LOT 1-CROSSROADS MIXED USE FILING NO. 3

COUNTY OF EL PASO, STATE OF COLORADO

GRADING & EROSION CONTROL PLANS

VTC-6

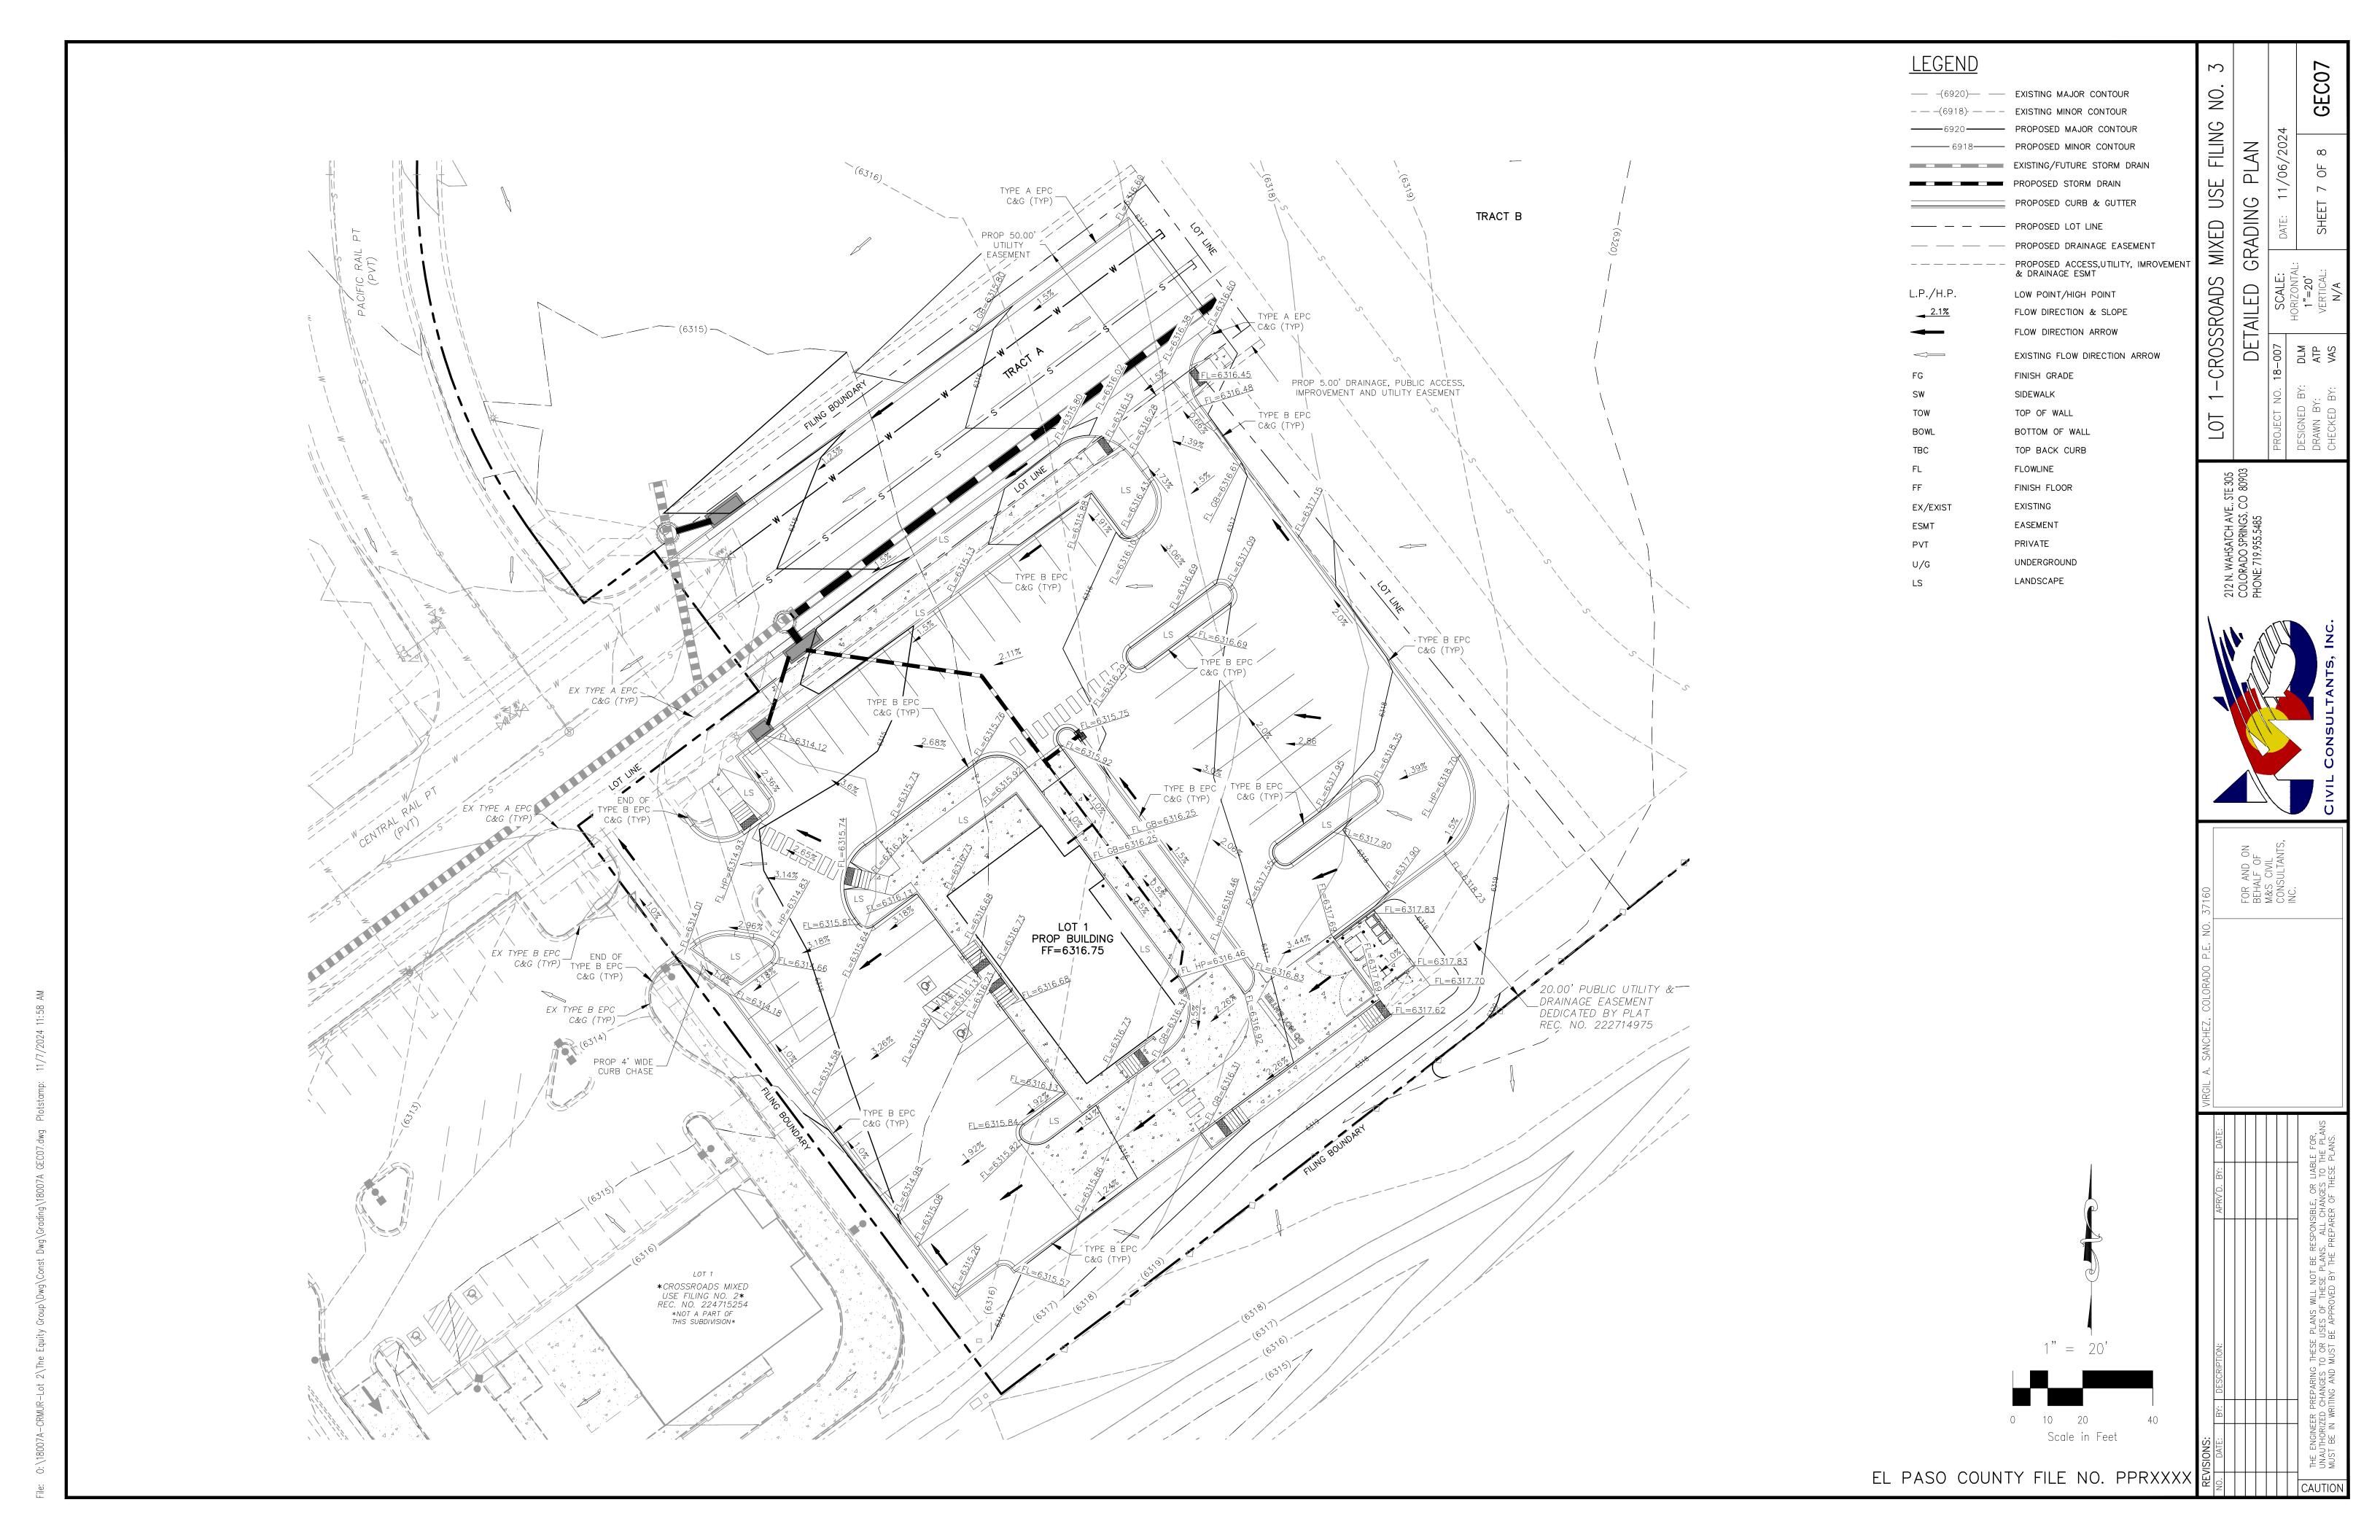
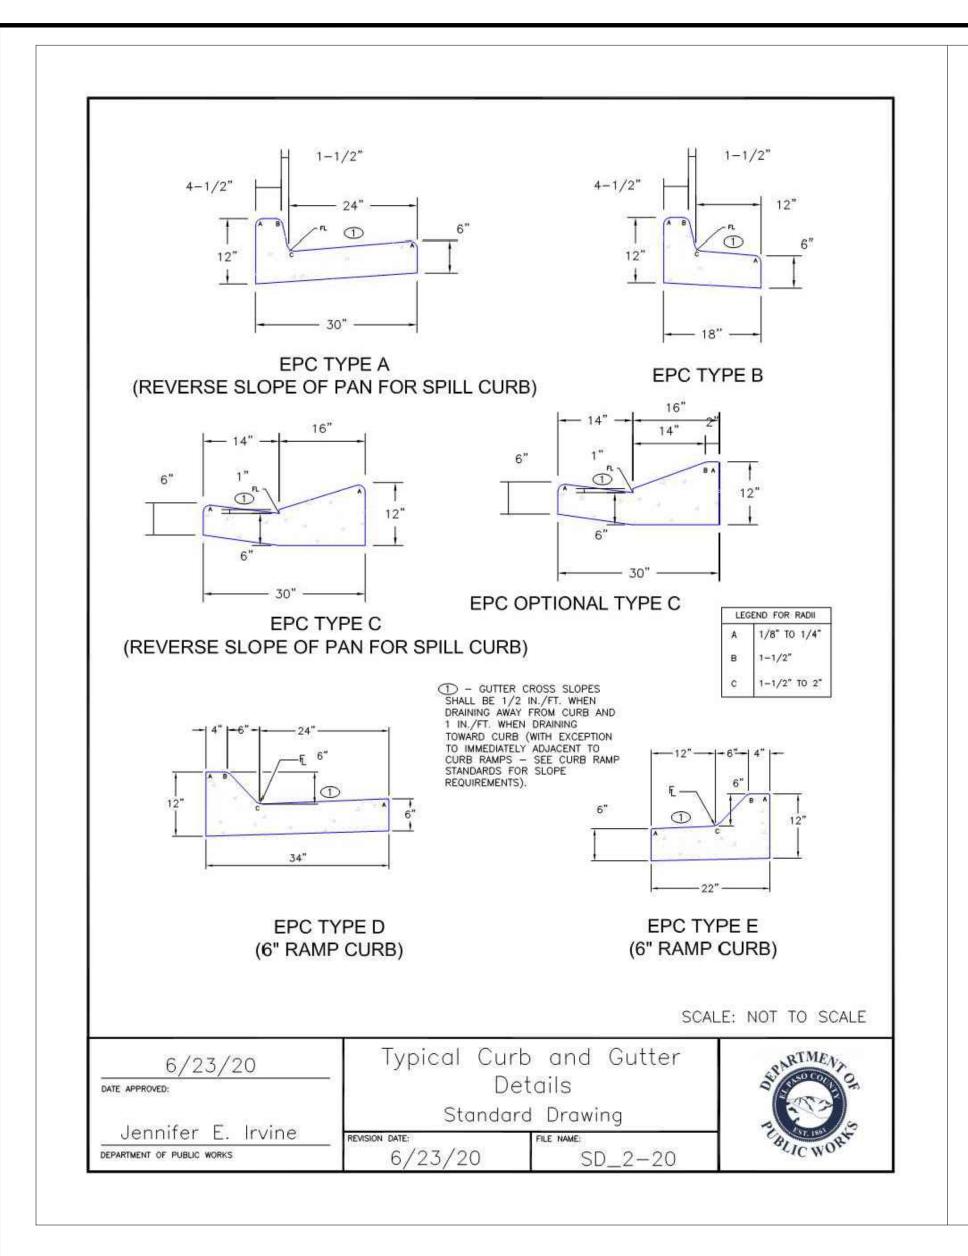
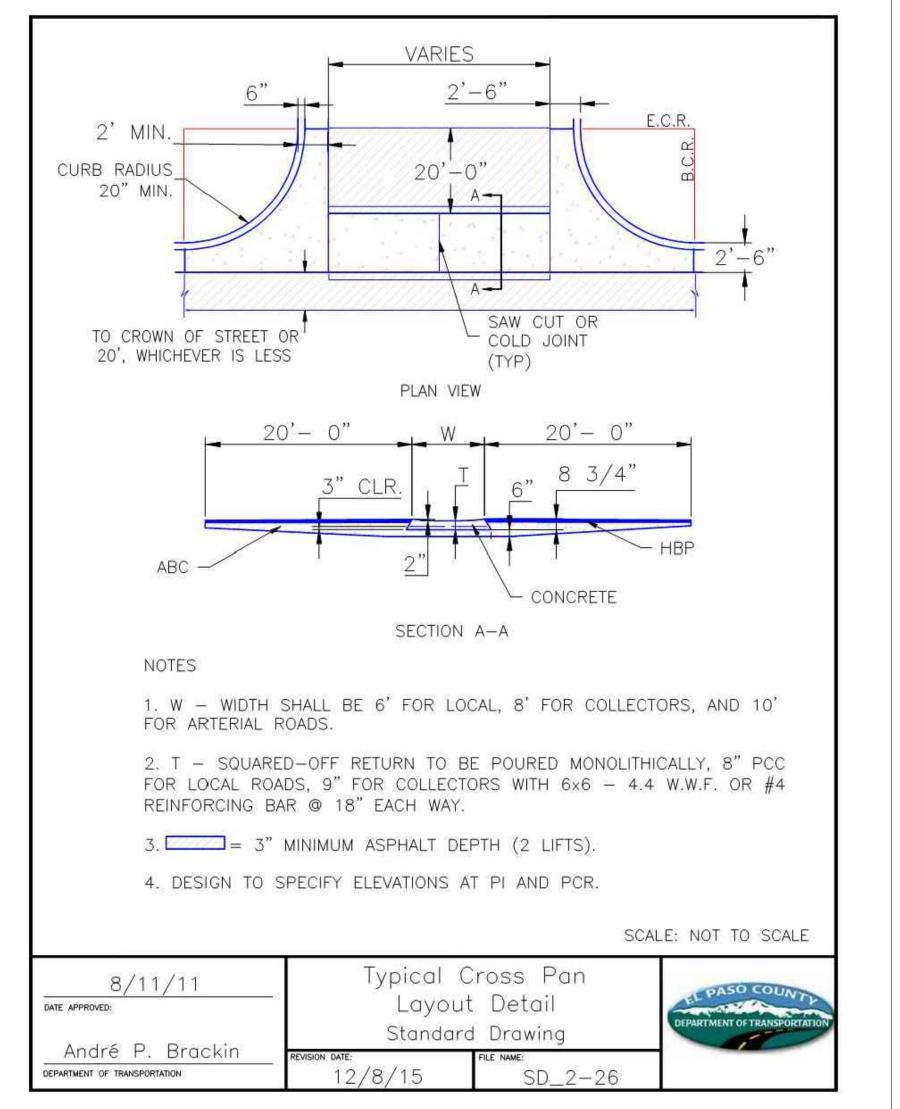
VTC Detail: Replace with EPC

approved VTC detail (VT-1 and

revise to be 75ft min length.
